## Annex 5: HW change description v1.2 to Test Report 20-1-0017102T03a-C01-A5

Hardware change description  
SICK LOCU1xx – UWB TAG

v1r3 -> v1r3.1 change description

Details for changes of LOCU Battery Basic/Advanced bottom layer:

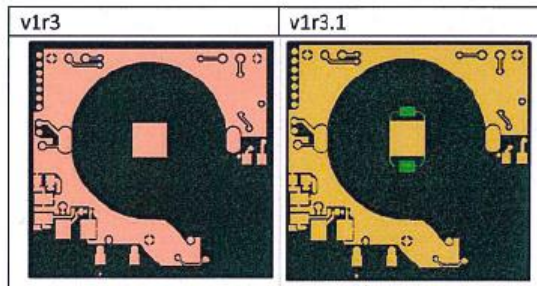
1. Battery holder: Pad adjustment of negative battery contact- milled grooves for battery holder are shifted in v1r3.1 comparing to v1r3. The pitch of grooves is increased by 0,45 mm.

- red mark - v1r3
- green mark - v1r3.1
